CHANGE = CHANGE

IN MAKING IN MOUNTING

Please Read Carefully!

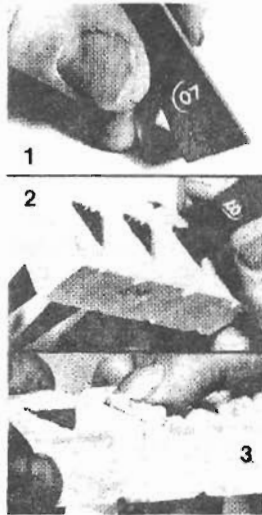
The location of the identifying cone number has been **changed** from the bending face of the cone to the side of the cone. (Figure 1).

This change in location of the identifying number was necessary in order to make the cones by a dry pressing process that produces a better, more uniform cone.

Insert the cone so that the **numbered side is toward the back** of the plaque (Figure 2). To properly position push firmly on the base of the cone. After all cones are inserted in the plaque press a dab of clay or refractory cement around the bottom of each cone to hold them solidly in place. (Figure 3).
